2. AMENDMENT/MODIFICATION NO. AOO1	3. EFFECTIVE DATE 1/29/2013	4. REQUISITION/PURCHASE REQ. NO.	5. PROJECT NO. (If applicable)
--	---------------------------------------	----------------------------------	--------------------------------

SRP38013Q0033 is being amended as follows:

Cyber Center Project

**Minutes from Site Visit
of January 22, 2013
for PR2284935 – PACOM Cyber Center Project**

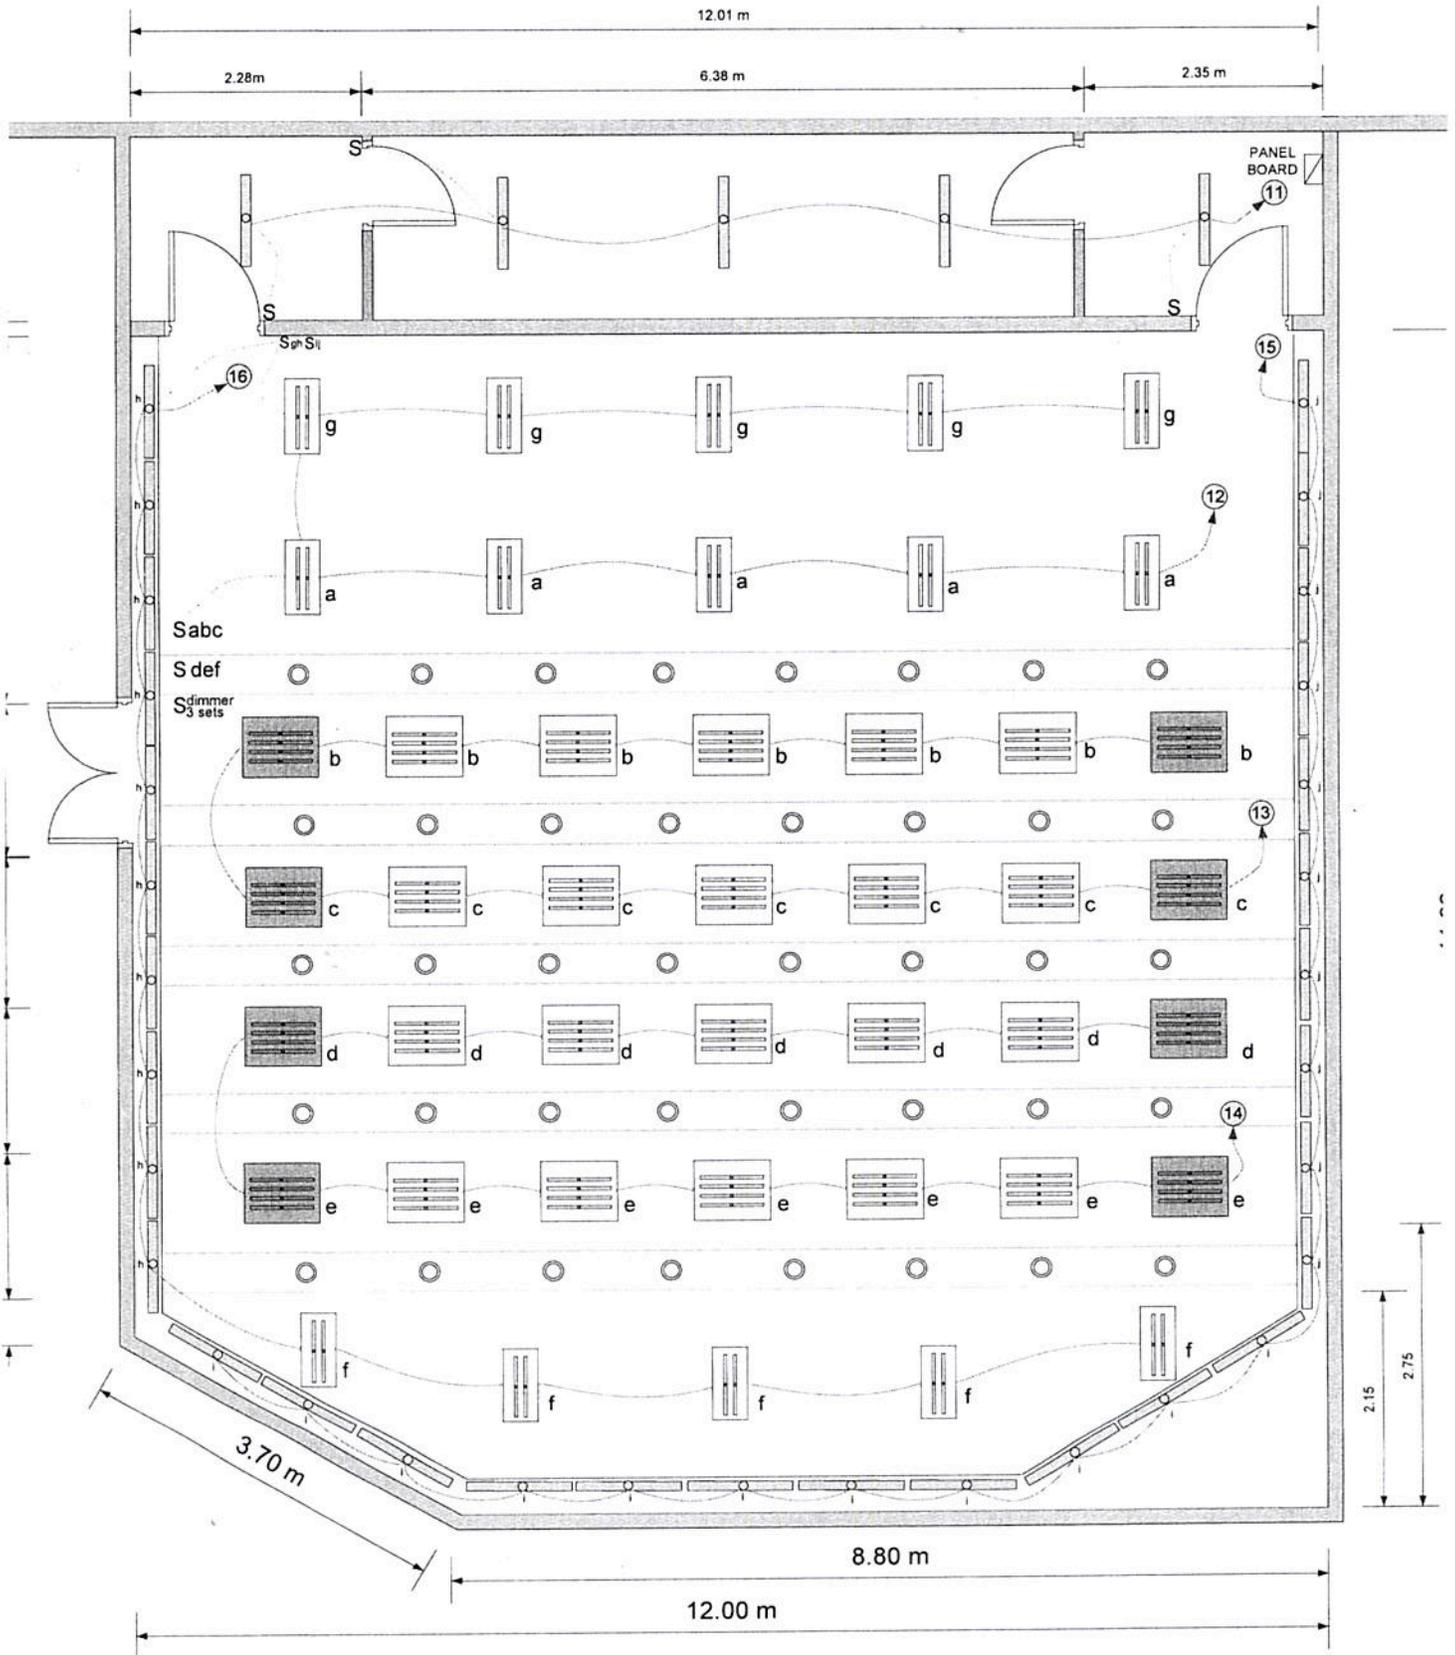
- The Scope of Work is hereby revised to **remove all Civil, Lights and Fixtures works**. The revised Scope of Work is hereby attached.
- The RFQ form is hereby revised to change **completion lead time in terms of number of working days from 10 days to 25 working days**.
- The original quote submission date of **February 4, 2013 is hereby extended until February 6, 2013**. Time of submission no later than 4 PM remain unchanged.

- Install duplex 3-prong convenient outlet serving two workstations in one location. Two circuits with dedicated home shall be used for one row as shown on drawings. Total of 10 circuits and dedicated home run to the panelboard.

- Install projector on the ceiling right above the last step. Projector to be provided by others.
- Separate conduit shall be provided for the data computer line and the power line for electrical convenient outlet. All conduits shall be concealed under the wooden floor. Conduit for power line shall be connected to the new panelboard and conduit for computer data line shall be inside the server room as shown on the drawings.
